April 15, 1983  
AEP:NRC:0637M

Donald C. Cook Nuclear Plant Unit No. 2  
Docket No. 50-316  
License No. DPR-74  
UNIT 2, CYCLE 4 SAFETY EVALUATION REPORT:  
RESPONSE REGARDING PLANT TRANSIENT METHODS

Response to the Plant Transient Analysis  
Issues Identified in the NRC Safety  
Evaluation Report (SER) for D. C. Cook  
Unit 2, Cycle 4

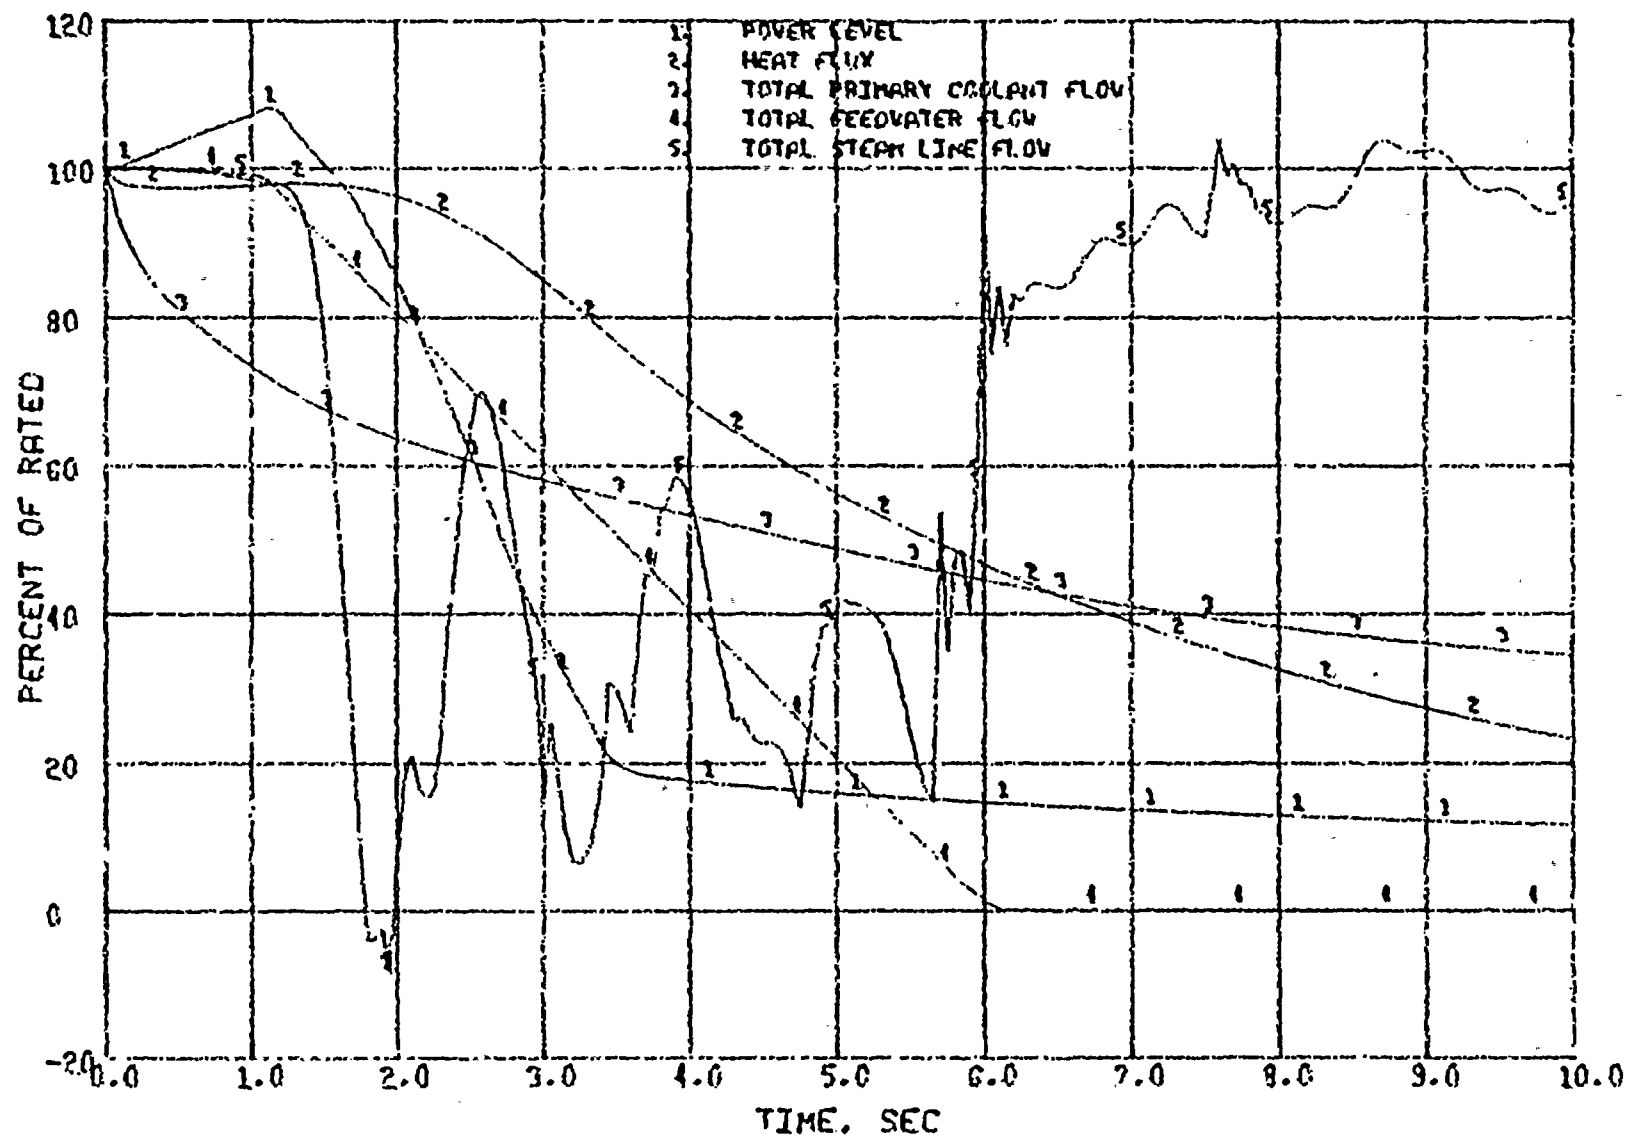
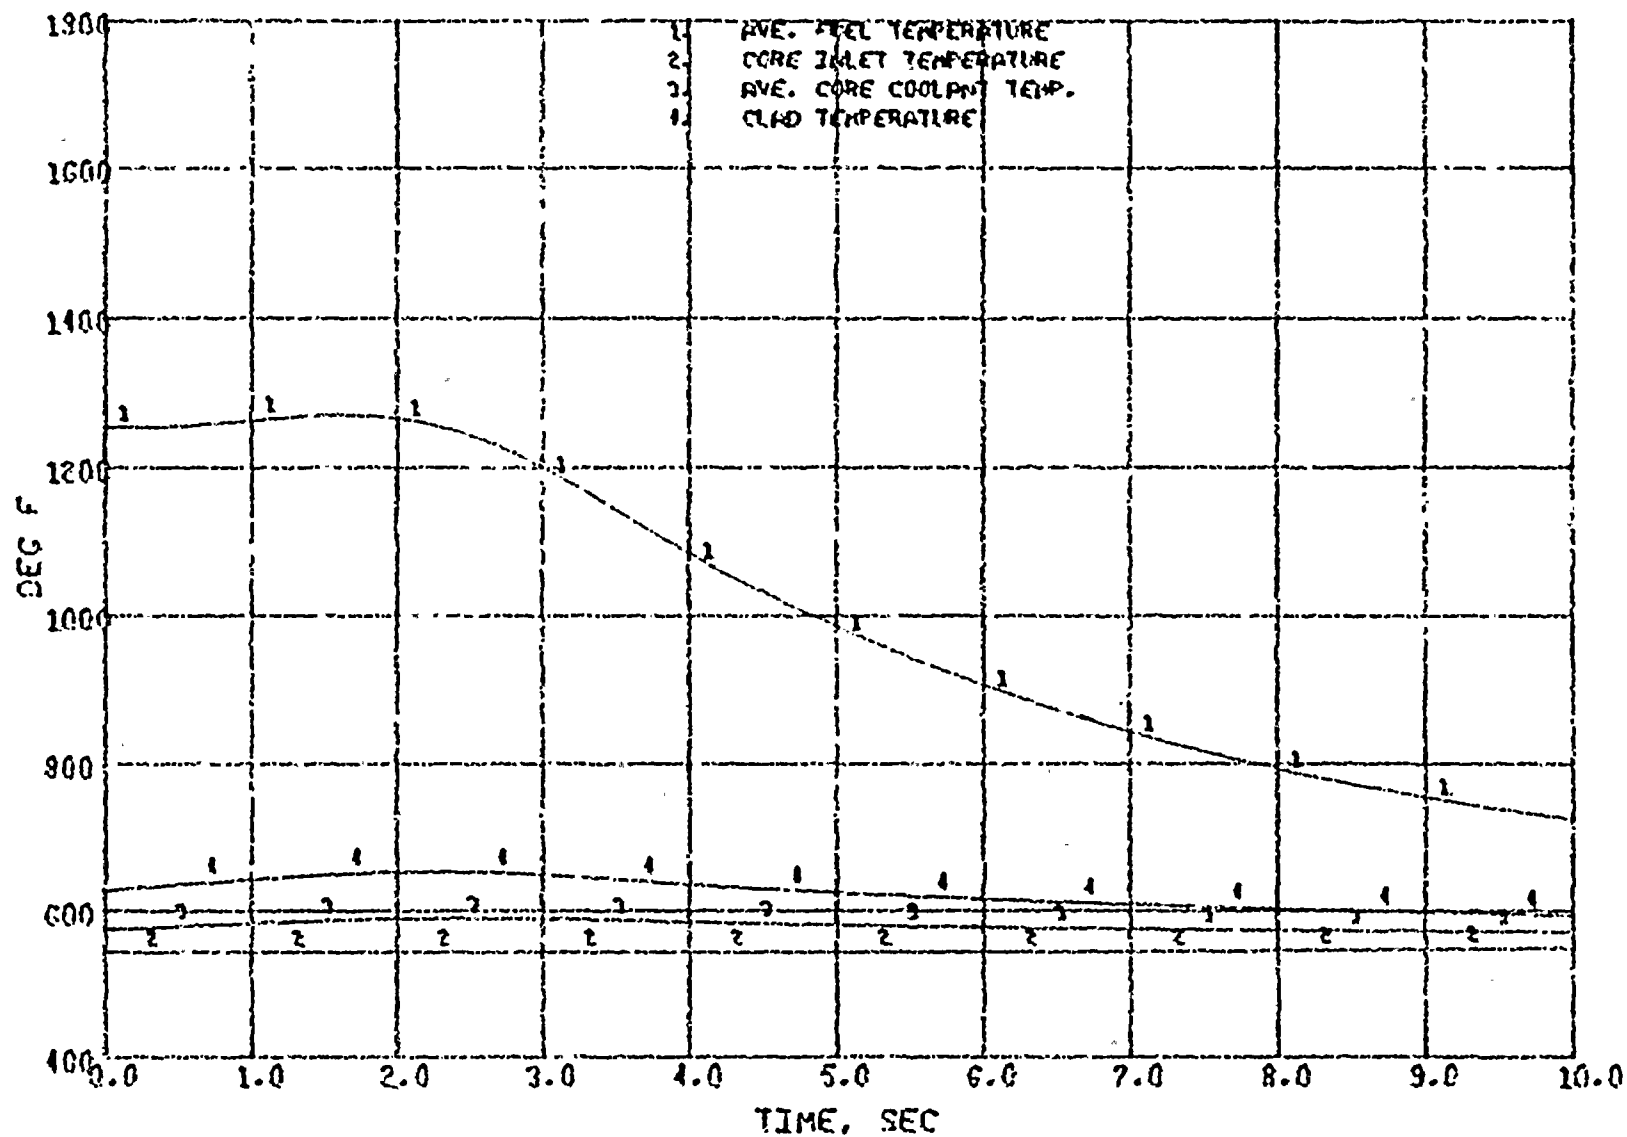
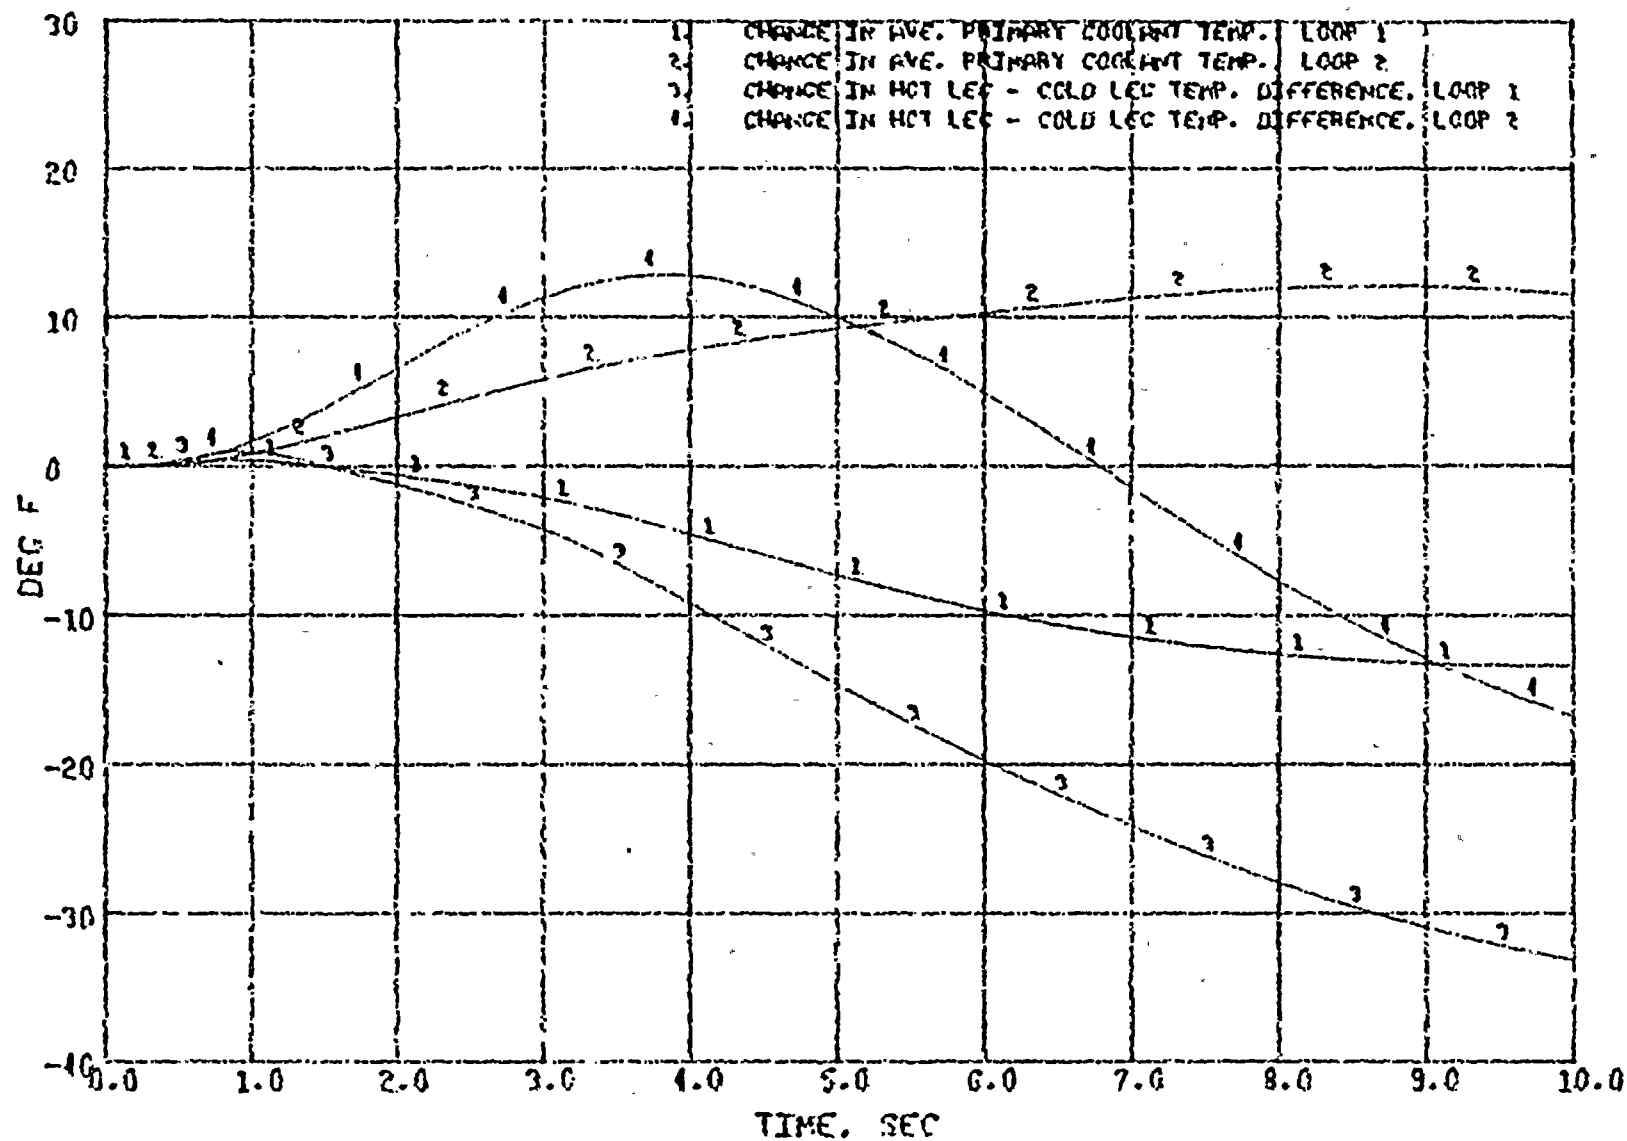
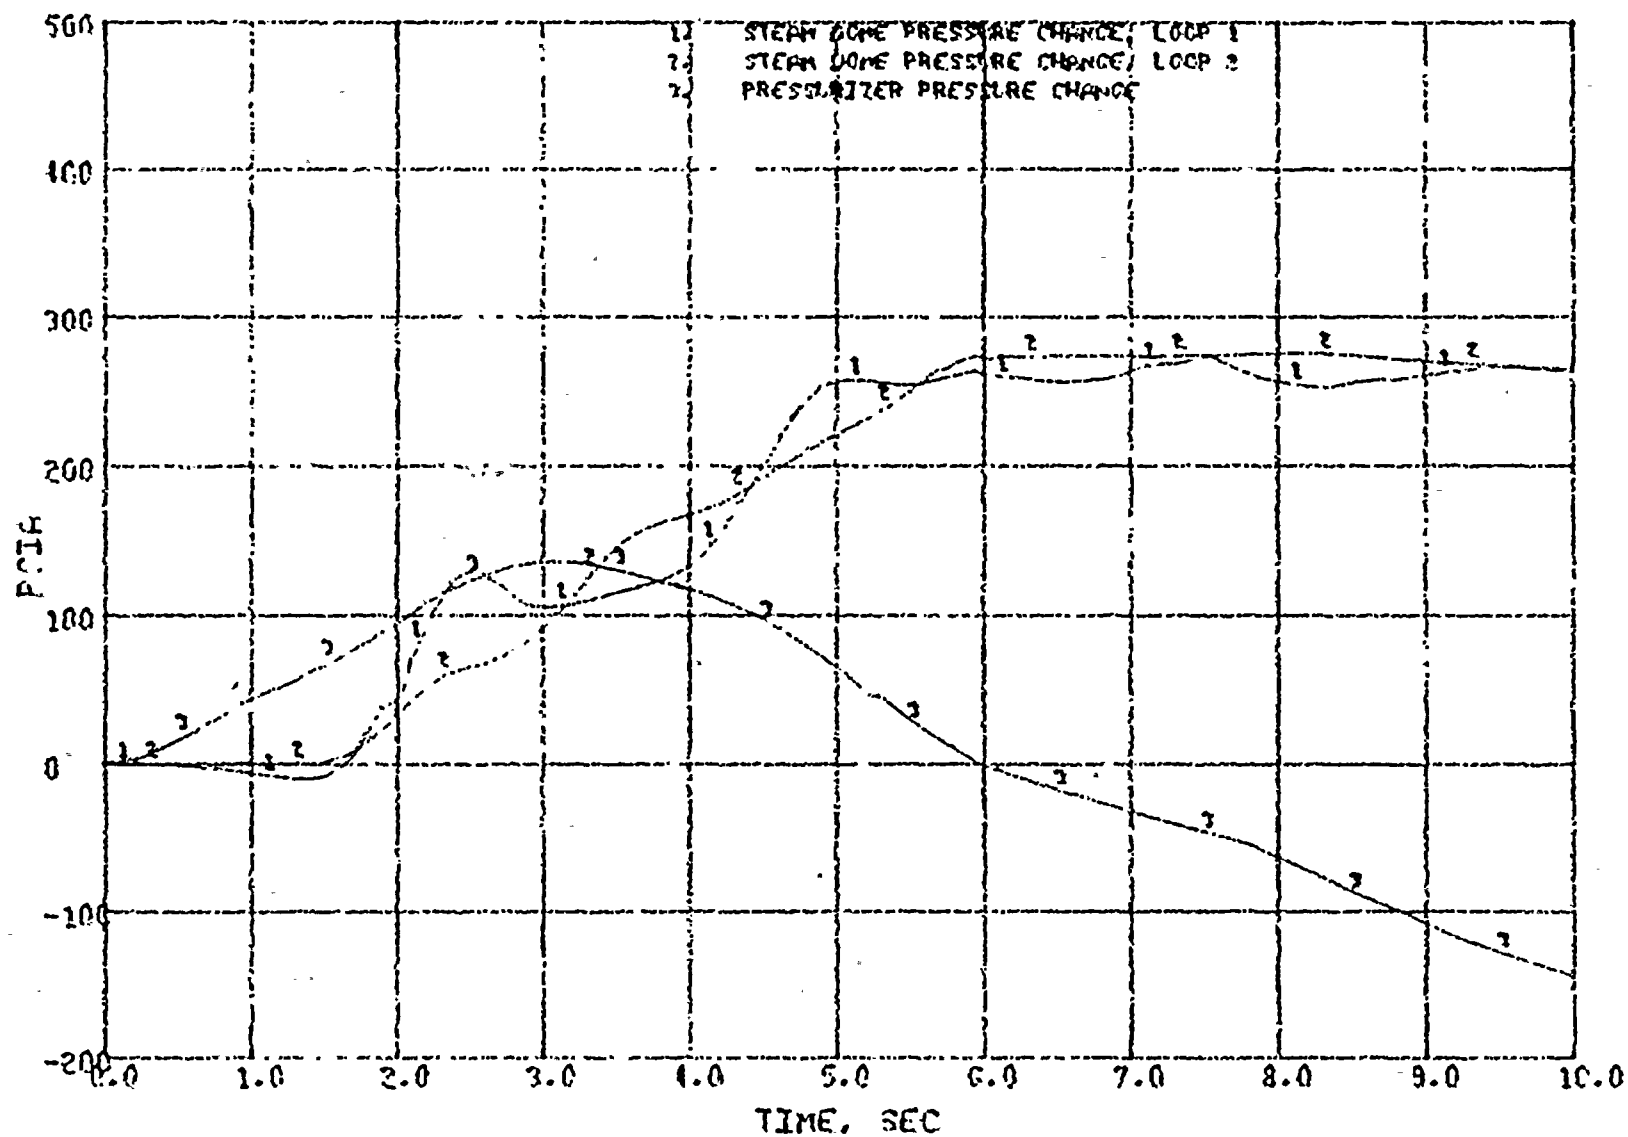
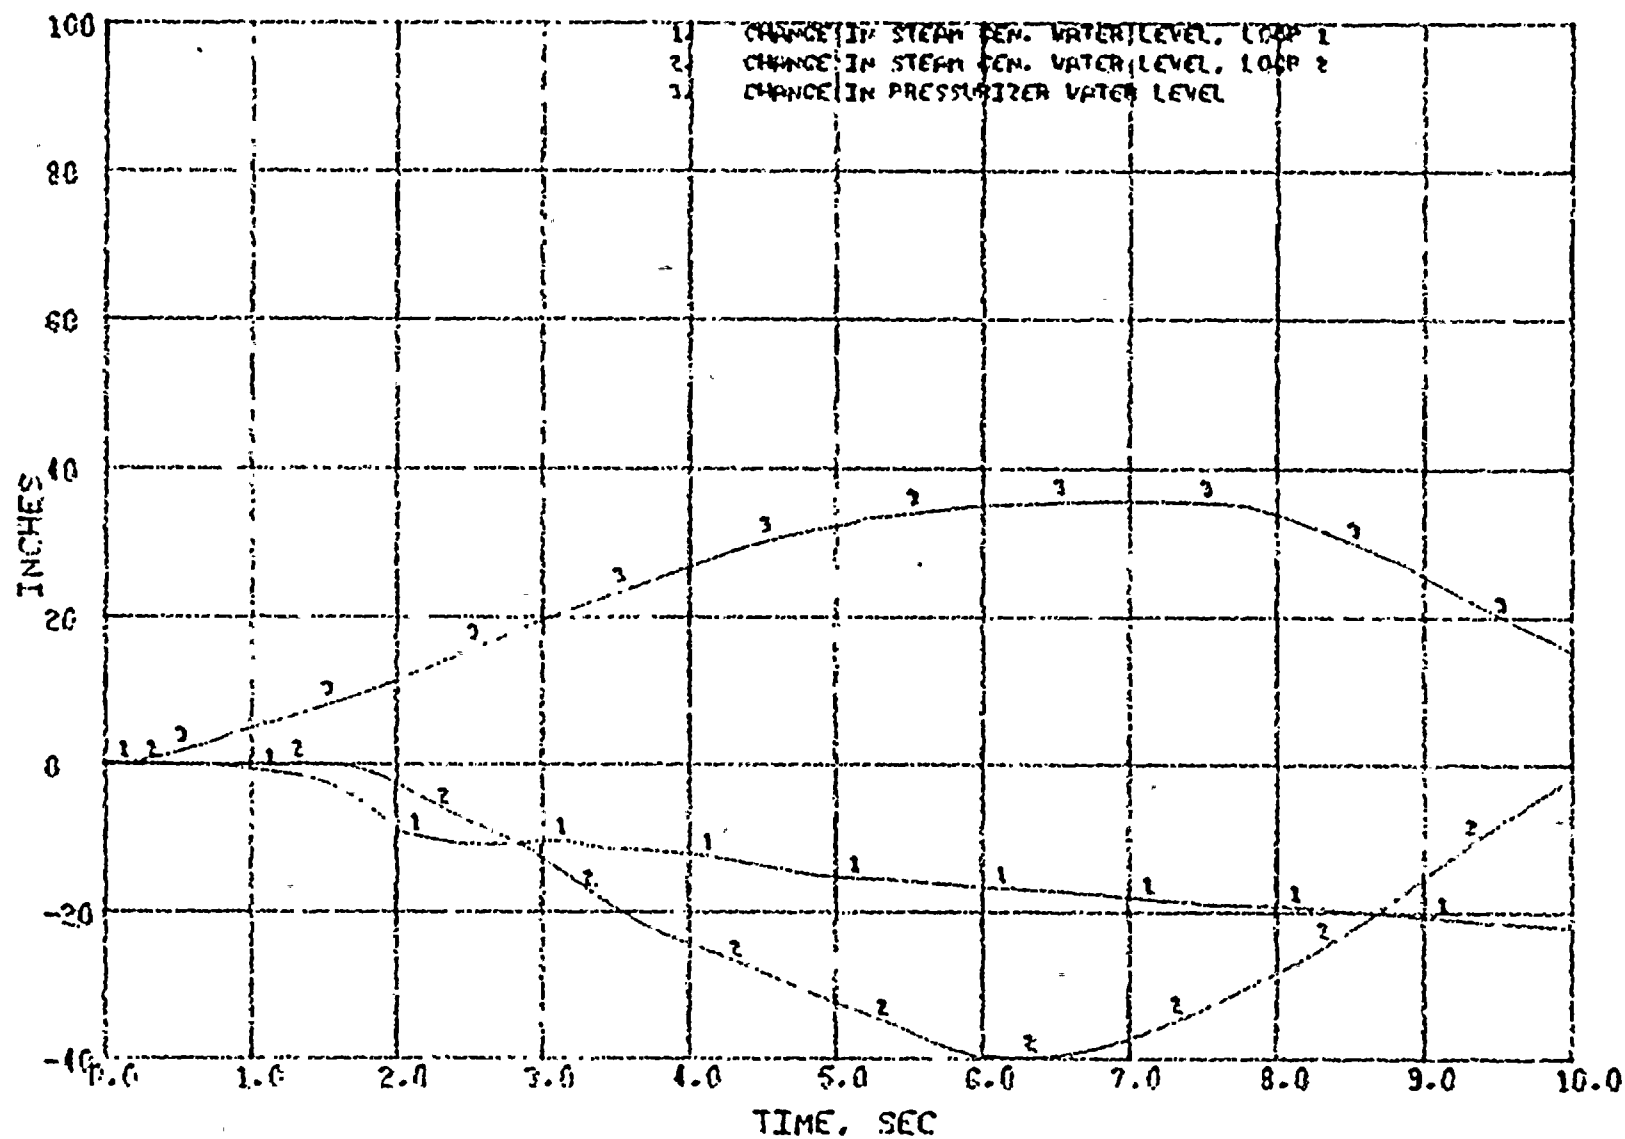
Item 1.2: Provide a confirmatory analysis which demonstrates that specified acceptable fuel design limits are not violated for the case of loss of offsite power. Justification for any delays assumed between reactor/turbine trip and loss of offsite power must be provided.

The requested simulation is attached. Inputs and methodology are identical to those used in Case 1, reported in XN-NF-82-32(P), Rev. 1, except that coastdown of the three remaining primary coolant pumps is assumed to occur simultaneously with the occurrence of the locked rotor. No delay is assumed between reactor trip and loss of offsite power. The calculated MDNBR is 1.34, only slightly degraded relative to the locked rotor case 1. Attached Figures 1-6 display the calculated system response.
